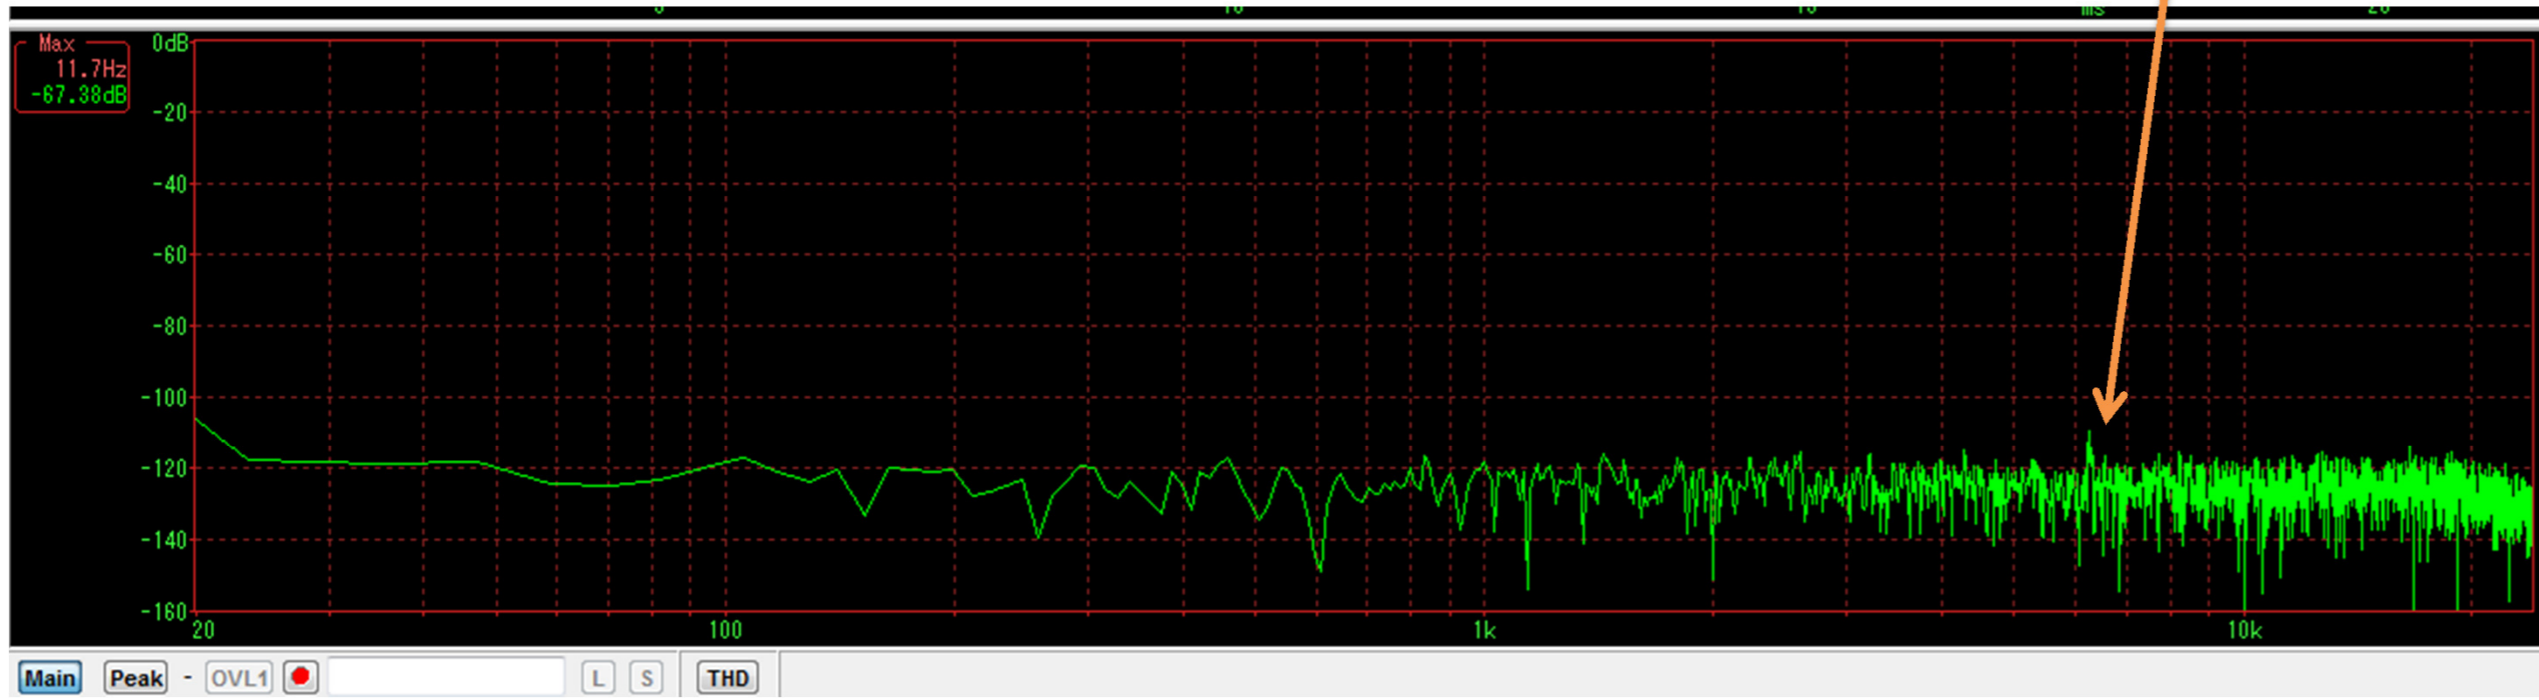
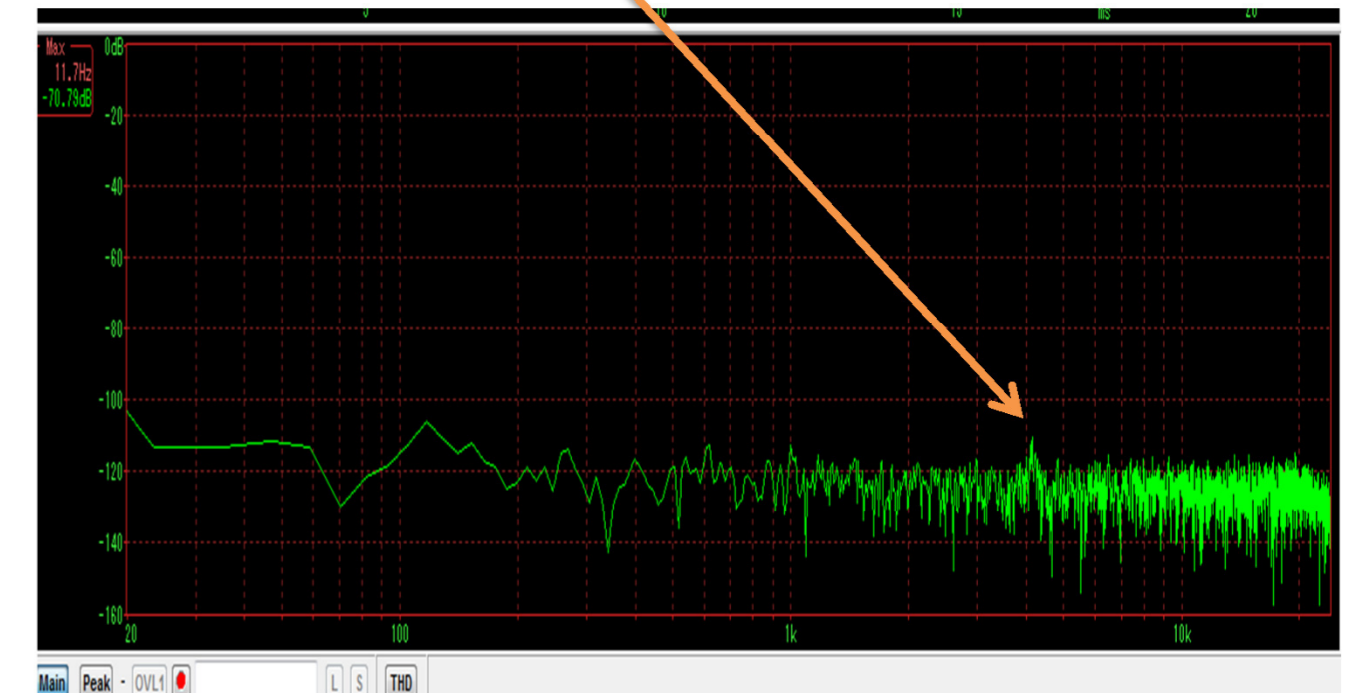
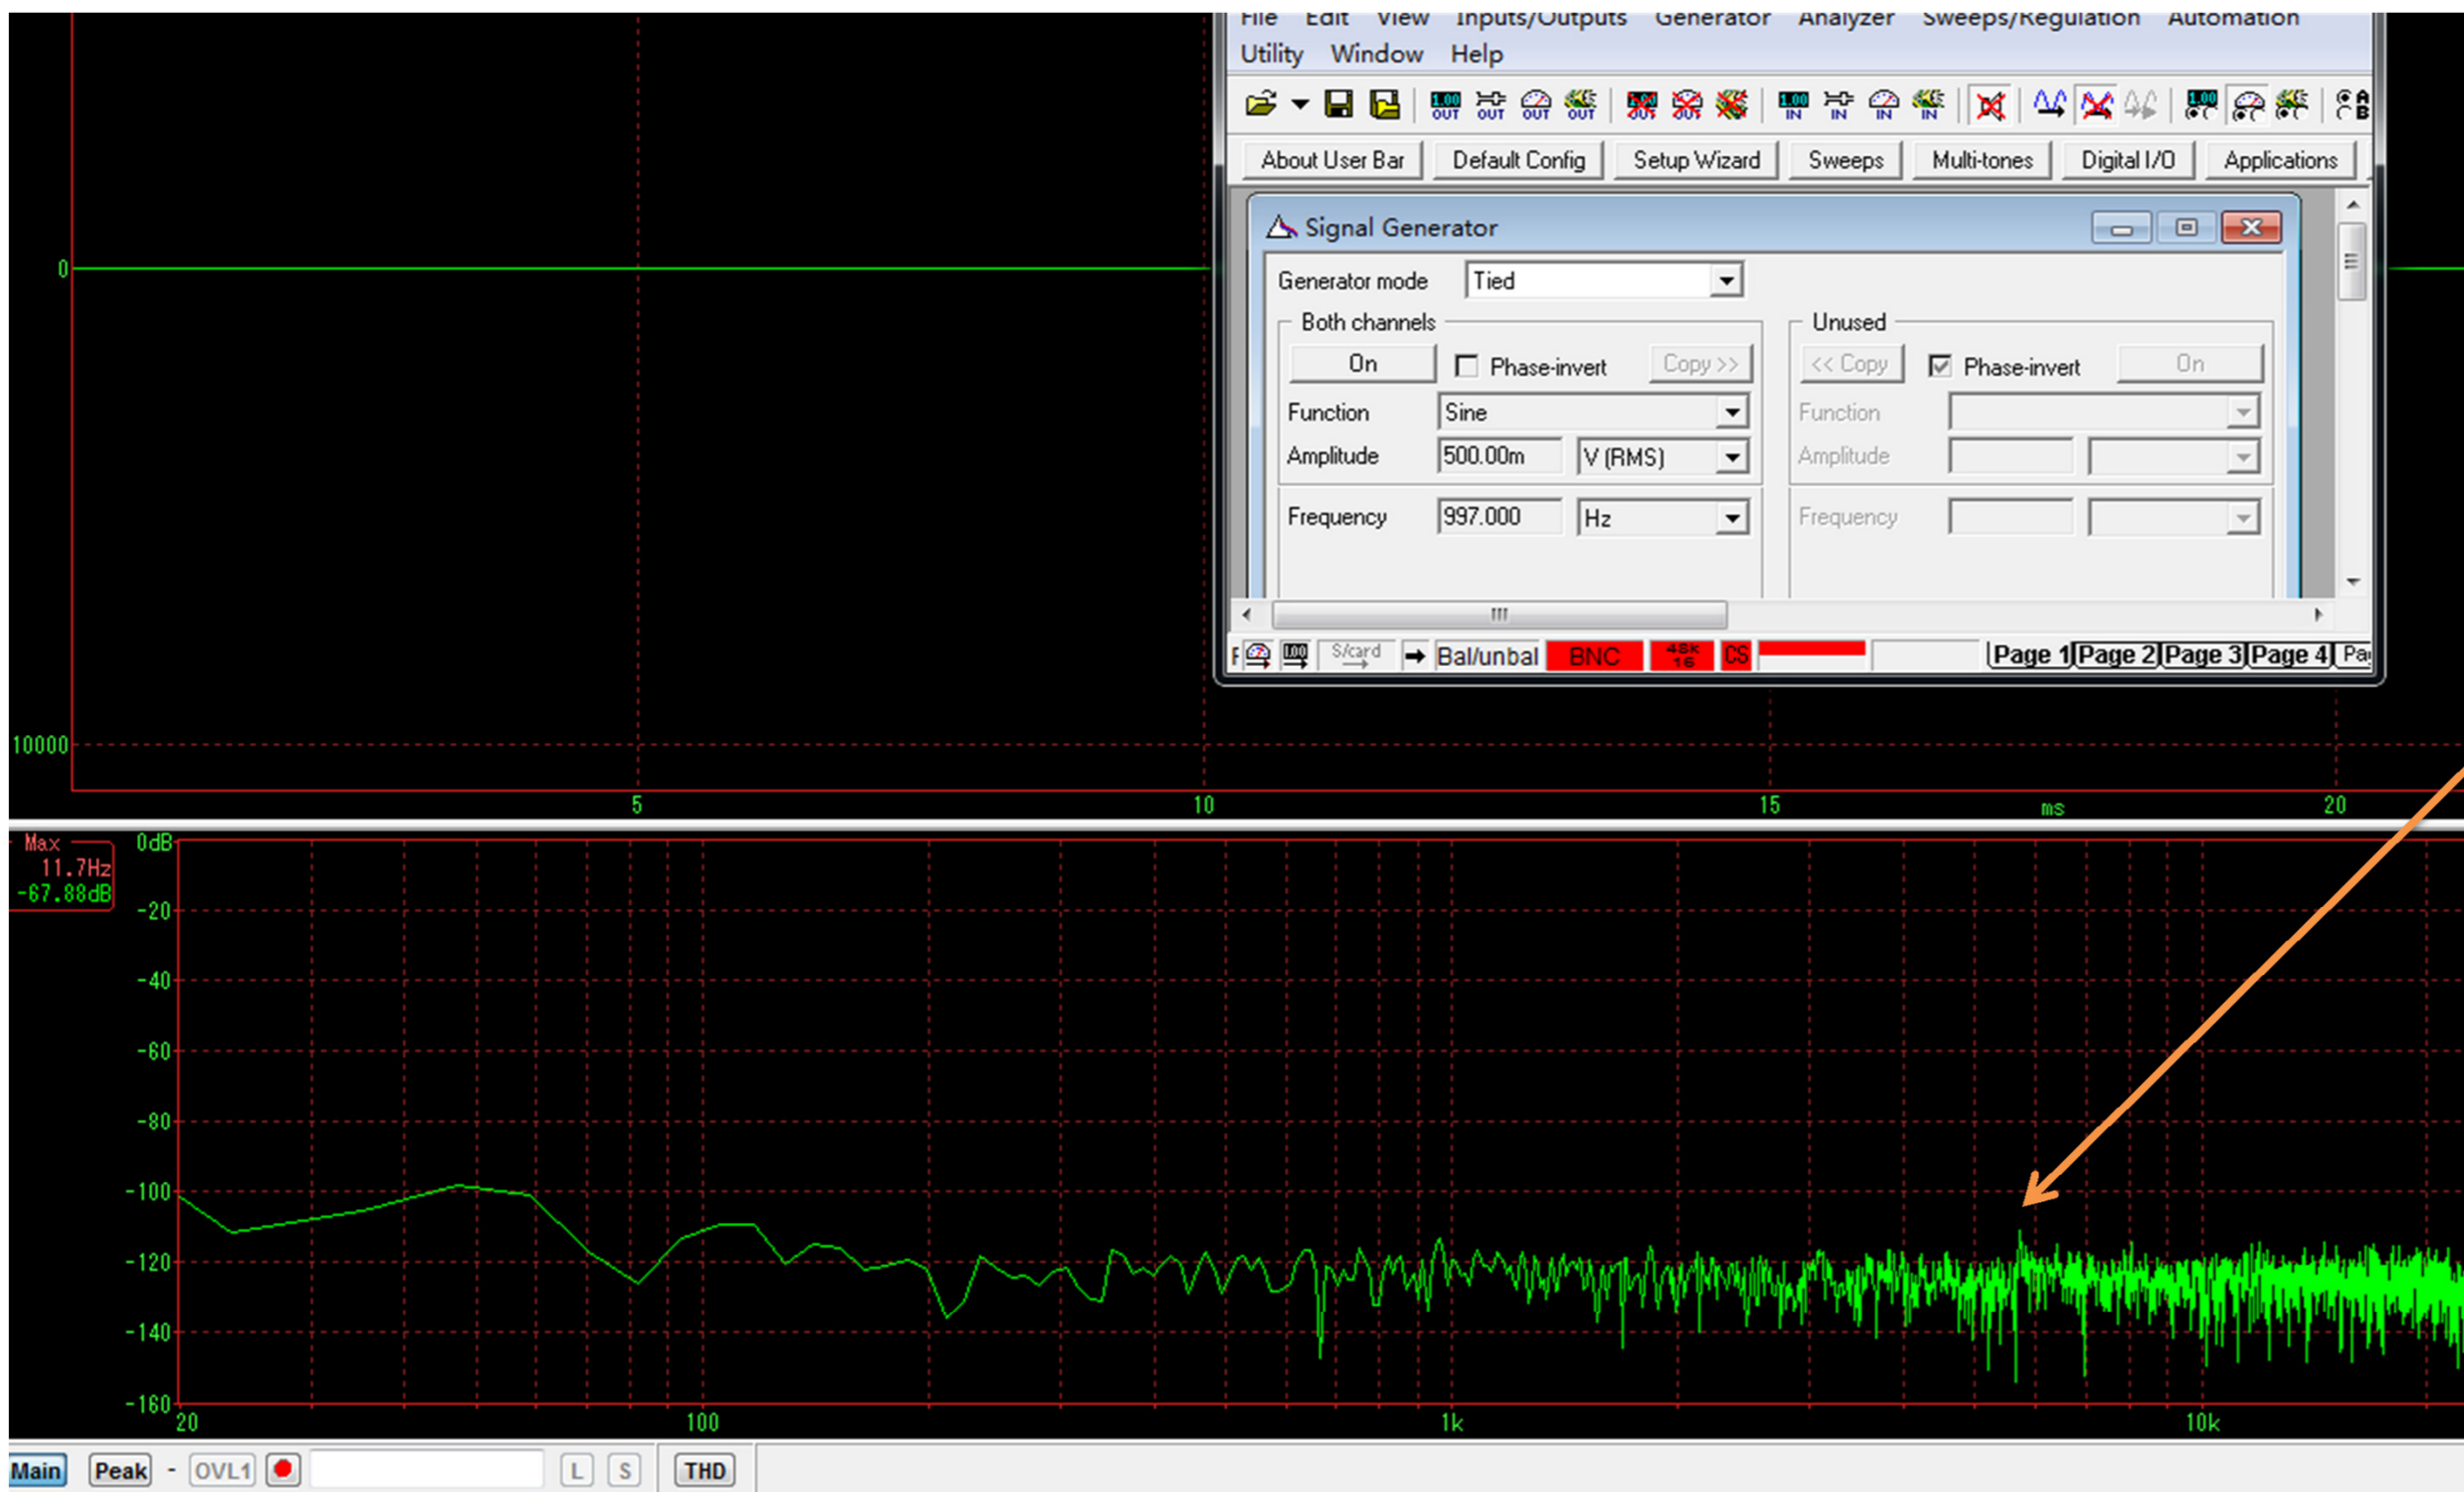
Please remove capacitors from pin 8 and 11.
Please place 22 ohm series termination on MCLK,DOUT,BCLK and LRCK. Is device operated as a slave? please send me the details of your timing.
It looks that there are long connections on input signal paths.These need to be minimized
Please set up the board as single ended. Please a 2.2u from pin 13 to ground very close to the IC pins. apply a sine wave of 1Khz 0.5v though 2.2u capacitor on pin 12.
Keep PGA Gain =0db
Check FFT.

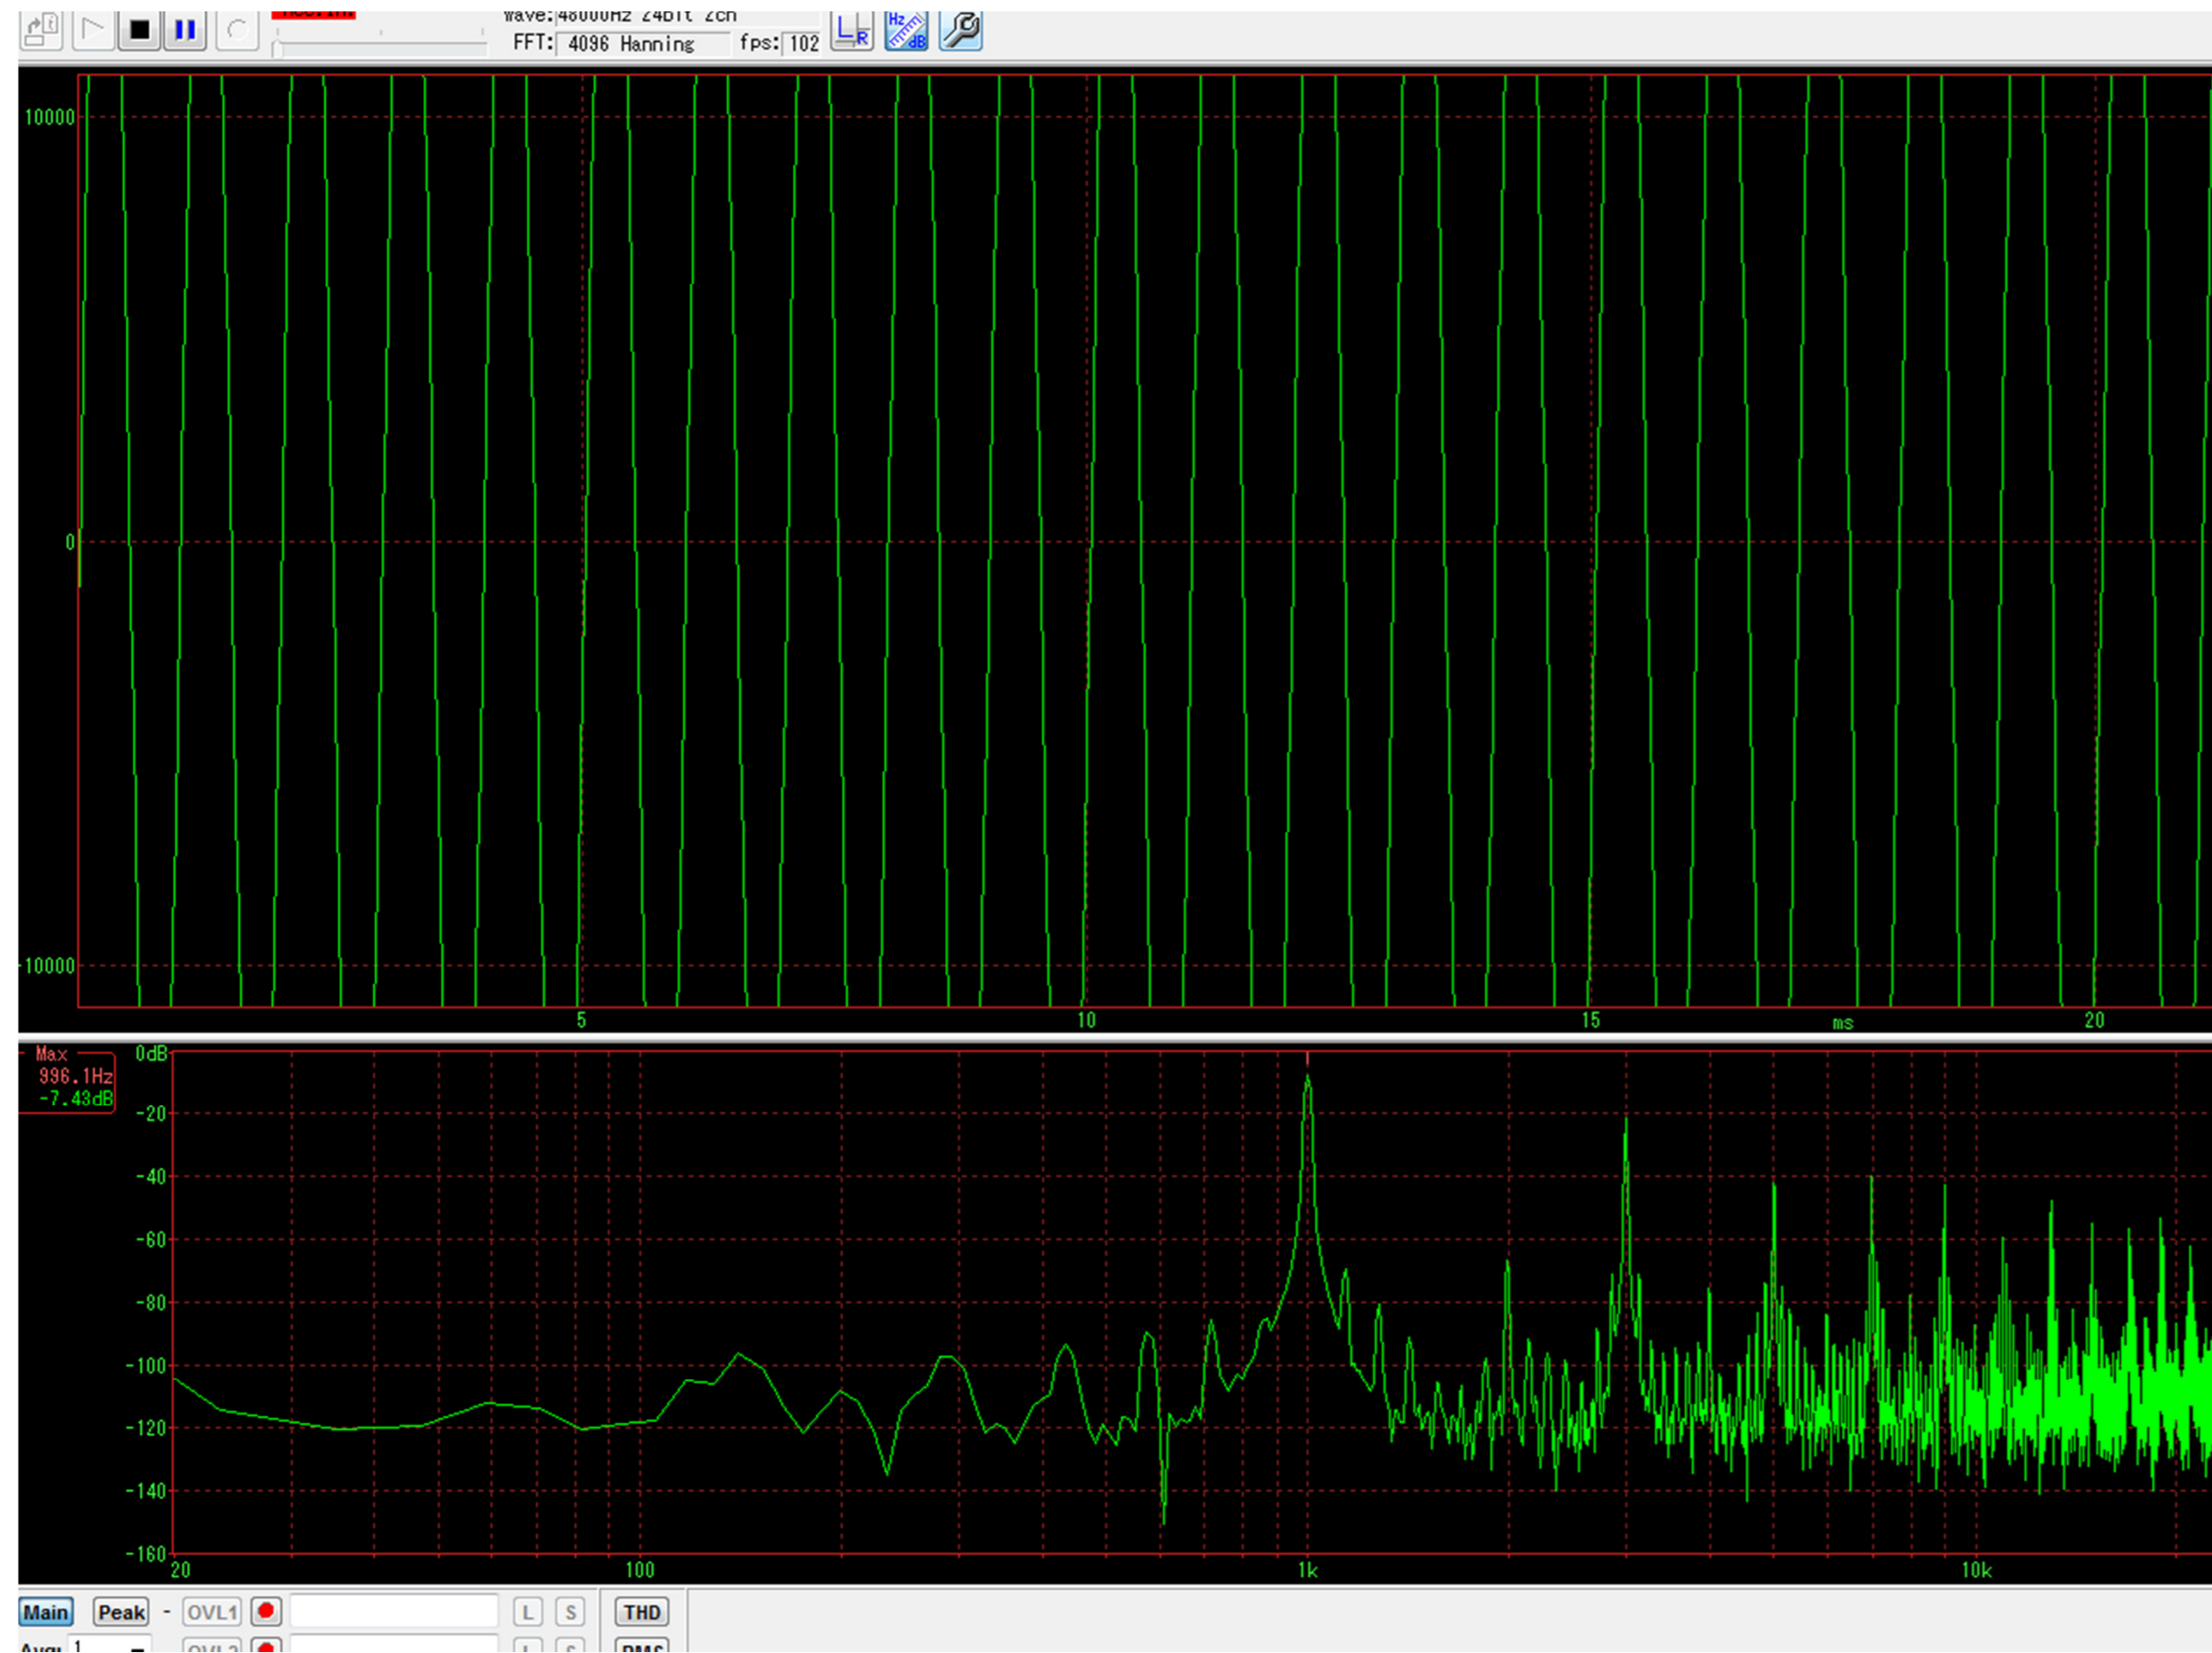
Before change

After change : Pin12 In = 0.5V 1KHZ OFF (Has the FFT Noise)

After change : Pin12 In = 0.5V 1KHZ ON

After change : Pin12 In = 0.25V 1KHZ ON
